**W A V E R L E Y**  
COUNCIL

## AGENDA

### **WLPP-2102.1** **PAGE 4** **48 Brown Street, BRONTE – Alterations and additions to existing dwelling house, including internal reconfiguration, extension to the existing front deck, entry portico and a first floor addition with front balcony. (DA-366/2020)**

### **WLPP-2102.3** **PAGE 90** **131 Military Road, DOVER HEIGHTS - Demolition of existing dwelling and construction of a two-storey attached dual occupancy with basement parking, swimming pools, landscape works, roof terraces and associated Strata subdivision (DA-259/2020)**

SITE PLAN

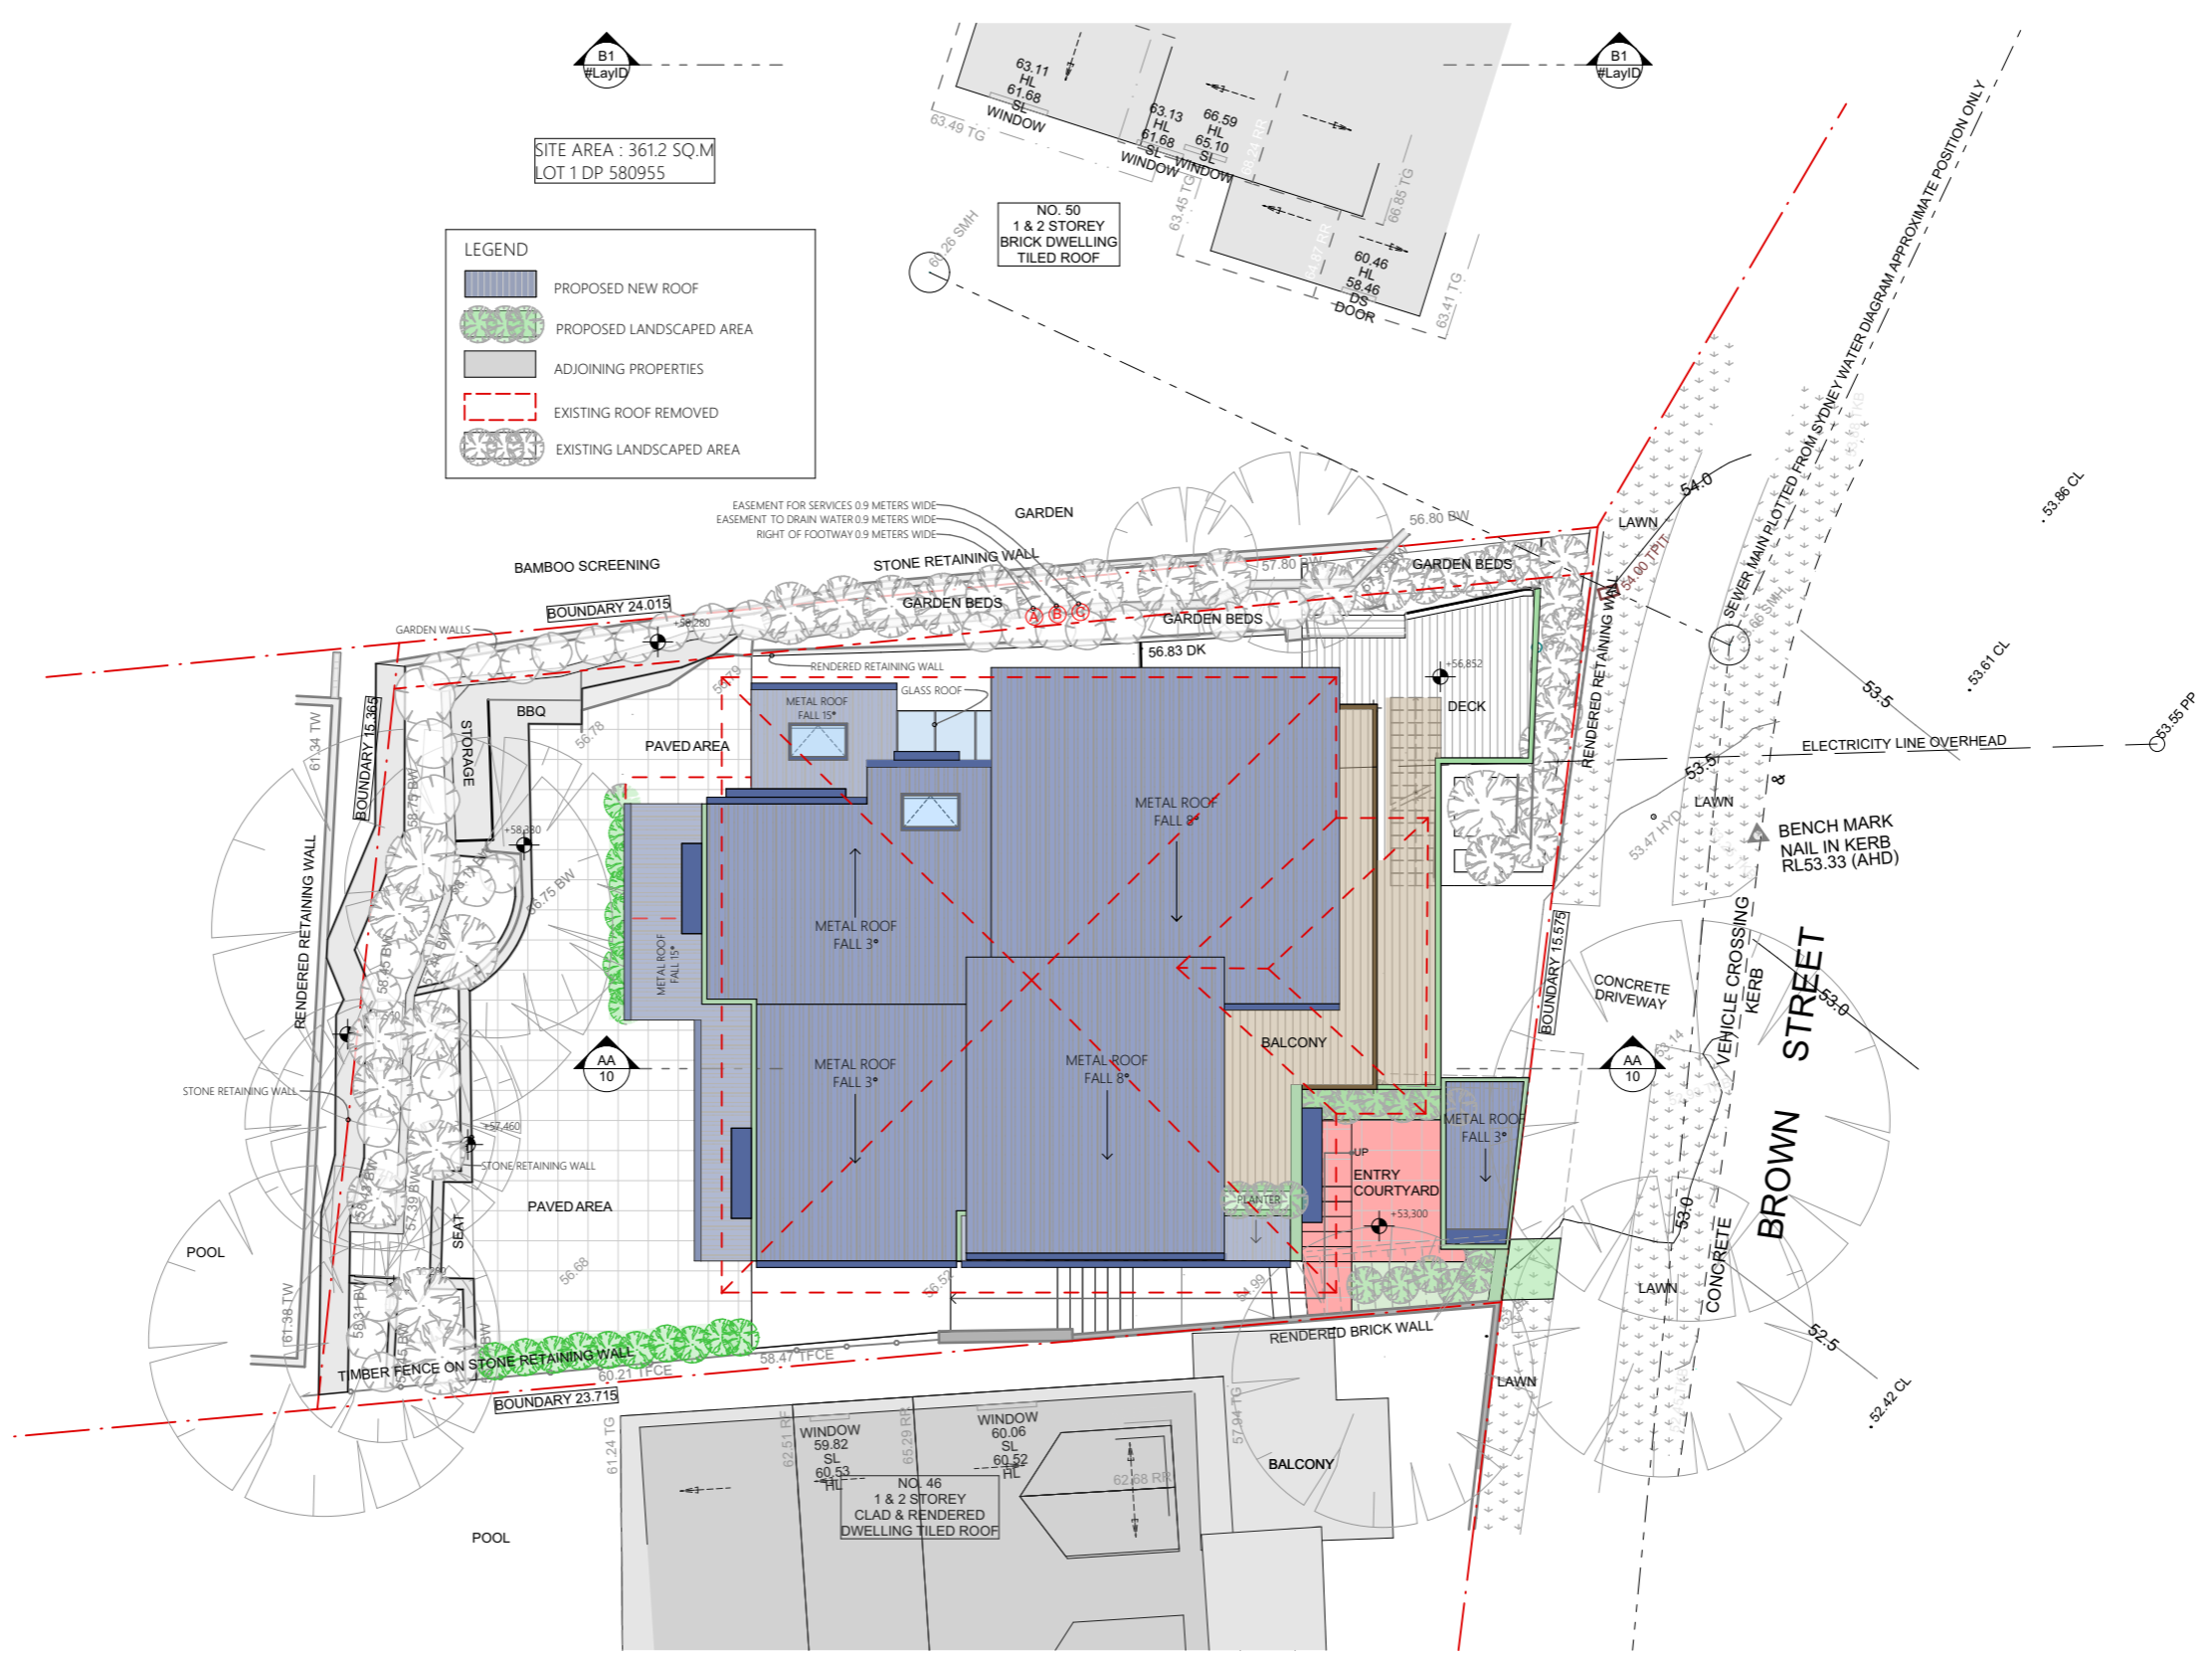
The submitted Water Management Plan prepared by Ezer Styles Architecture Pty Ltd, Project No. 143/2019, Drawing No. 03, dated September 2020, are considered unsatisfactory.

- a) OSD Details: The provided plans do not provide sufficient details of the proposed On-Site Stormwater Detention (OSD) tank and its details e.g. pit dimensions, cross & long sections, significant water invert levels of inlet and outlet pipes, details of Discharge Control Pit, orifice plate details including orifice diameter, depth of water above centreline of orifice etc., pit overflow, OSD plaque, OSD warning sign and catchment plan. Council's mandatory OSD checklist as set out in page 22 of the Council's Water Management Technical Manual shall be submitted.
- b) Seepage water from basement car parks and sub surface flows from structures that intersect high ground water flows shall be pumped and harvested onsite or piped to the underground stormwater drainage system. Direct or indirect piped connections to Council's street gutter is not permitted.

The applicant must submit plans and specifications to comply with the current Waverley Council Water Management Technical Manual and Development Control Plan (DCP) at the time of engineering plan approval. The submitted plans shall be prepared by a suitably qualified and practising Engineer and include:

GROUND FLOOR

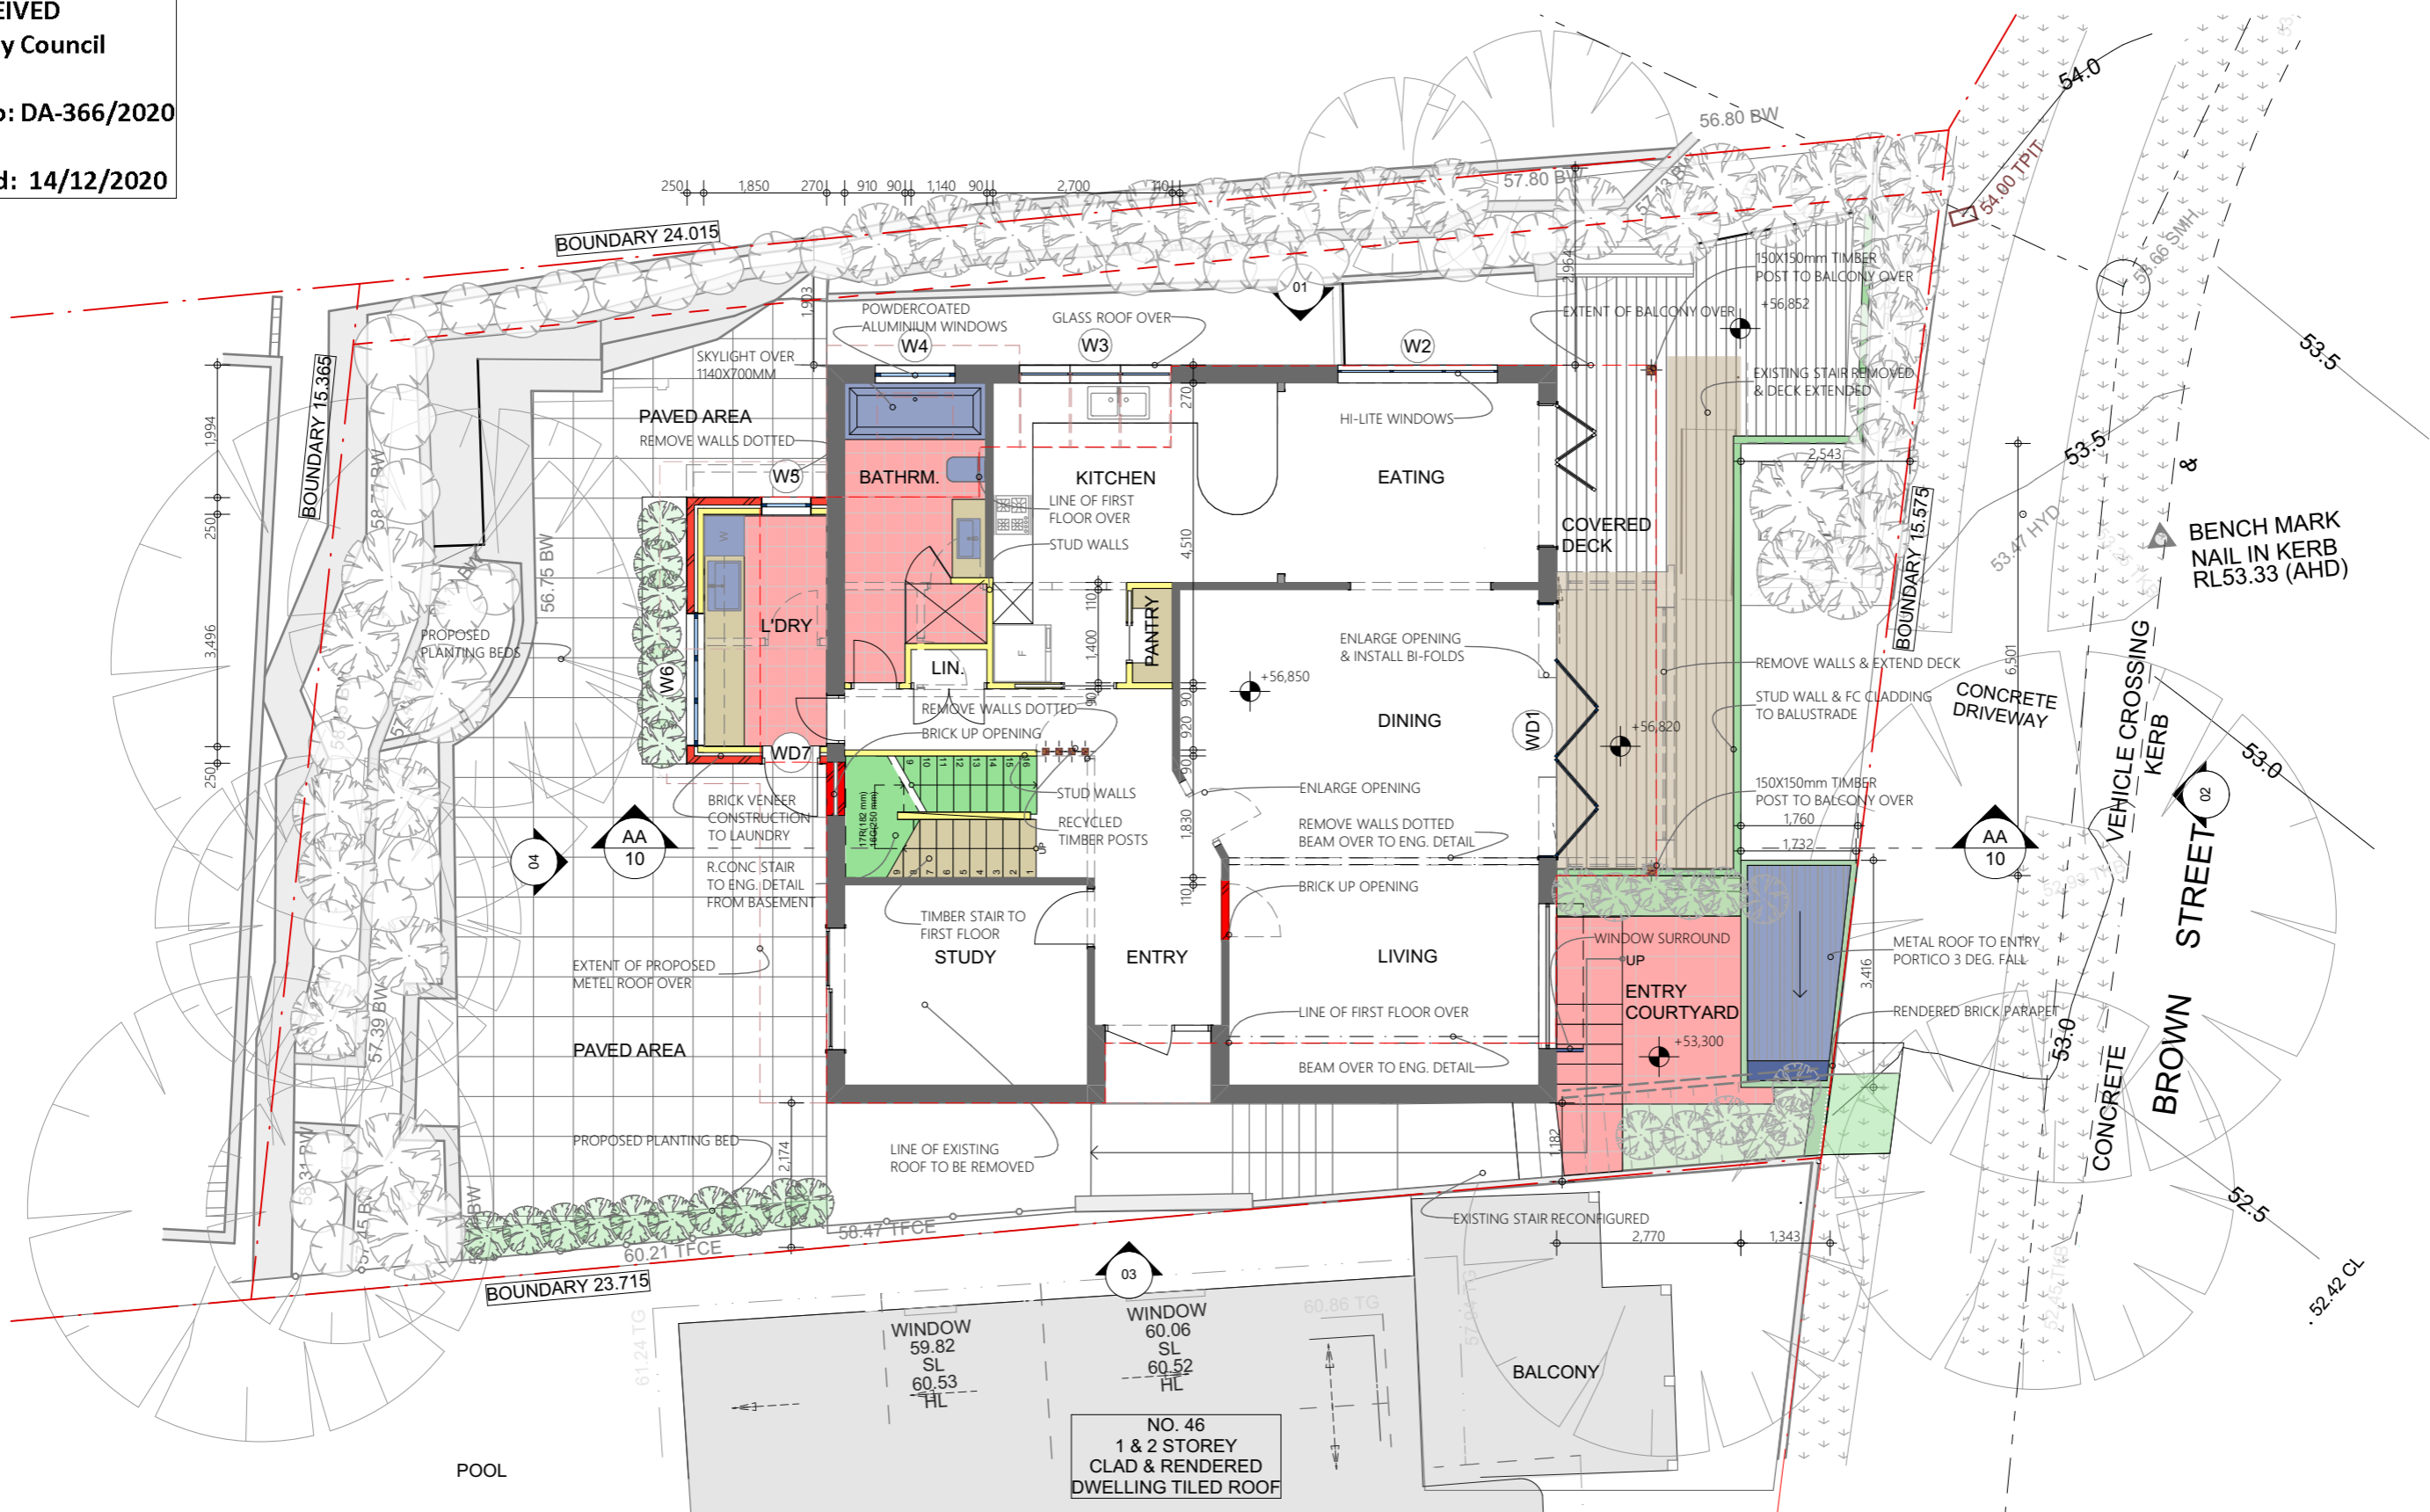
The amount of deep soil within the front open space is non-compliant with the WDCP control. The site is unique and due to site constraints, it is difficult to achieve full compliance. However, it is considered that additional deep soil planting can be provided within the front setback through the removal of a small section of the path, as shown in **Figure 10** below. A condition is recommended that the entry courtyard to the lower ground be reduced in width to be no greater than the landing with this space being dedicated for deep soil planting.

- (a) The width of the entry courtyard at lower ground floor is to be reduced to be no greater in width than the landing to the stairs. The remaining section is to be deep soil planting.
